**Historical Architectural Review Board
COA Final Review Sheet**

HDC-2023-00050

Address: 1625 W. Linden Street

Proposal: Install fiberglass casement windows (violation correction)

**Side façade of 1625 W. Linden Street with the historic window
circled in red, 2016.
(Google StreetView)**

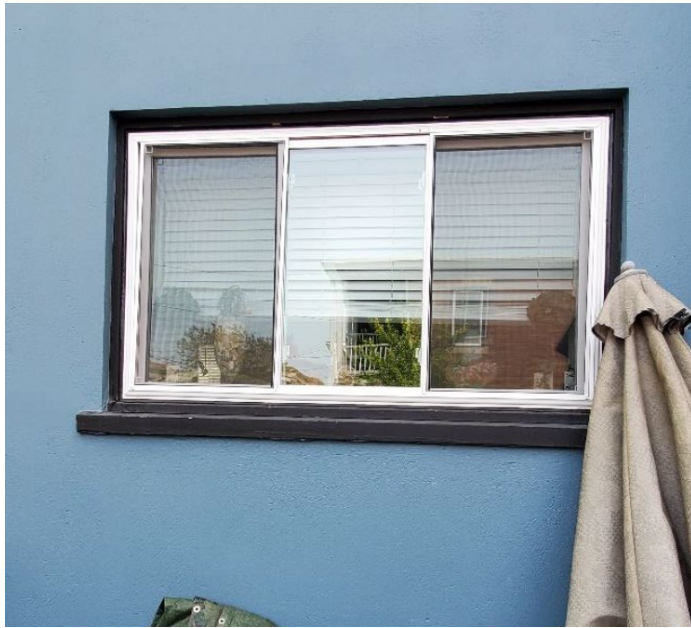
On February 6, 2023, staff issued a notice of violation for the replacement of two first-story windows along the West Street façade with new vinyl windows. The applicant contacted staff about the violation after receiving notice and has been working with the city's Lead Hazard Control Program staff to mitigate the lead paint at the property by replacing windows throughout the building. This application from the Lead Hazard Control Program staff proposes to correct the violation at the tripartite window by removing the vinyl replacement window and installing a new fiberglass window. Staff notes that the new configuration will close but not an exact match to the historic configuration.

Vinyl replacement window in violation.
(Applicant)

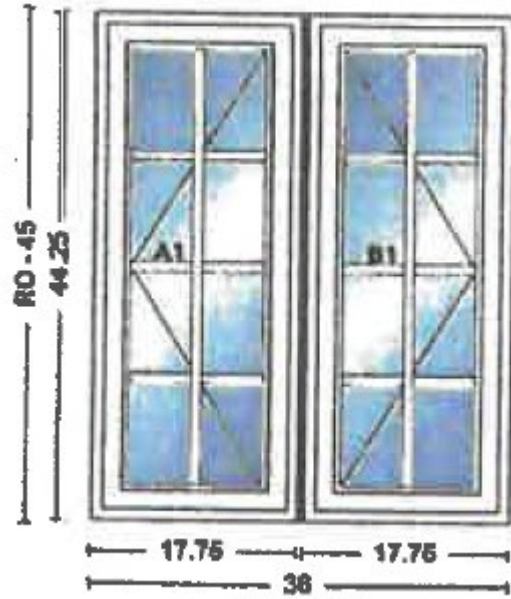
The opening on the West Street elevation historically consisted of three double-casement windows with eight panes in each leaf. The owner removed the historic windows and inserted a vinyl tripartite slider that does not meet the design guidelines. To correct the violation, the Lead Hazard Control Program staff has submitted a proposal to remove the vinyl window and install two pairs of fiberglass double-leaf casement windows with an eight-pane configuration in each leaf. The simulated divided light windows would feature exterior muntins.

The windows generally meet the design guidelines, because they would be an appropriate material and would maintain the type, operation, profile, and general appearance of the original casements; however, the configuration would change from three casements to two casements. Staff finds that the configuration change does not meet Guideline 3.5.9, though the change would not result in an infill or change to the masonry opening. The applicant contends that the manufacturer cannot fabricate casements narrow enough to allow for the installation of three sets of windows to match the historic configuration.

Staff notes that Lead Hazard Control Program has submitted an application to replace most windows at the property and that the remainder of the windows will meet the design guidelines and will match the historic windows. To maintain consistency throughout the entire property, staff suggests that the vinyl slider window be replaced with the same Andersen 100-series windows that will be used throughout the building, despite the change in configuration.

The HARB discussed the two options and agreed that the two 36-inch French casements would be more appropriate.

Mr. Jordan moved to approve the application presented on 9/5/2023 as submitted to install two 36-inch fiberglass French casement windows at 1625 W. Linden Street, pursuant to Chapter 3, Section 3.5 Windows. Mr. Lichtenwalner seconded the motion, which carried with unanimous support.
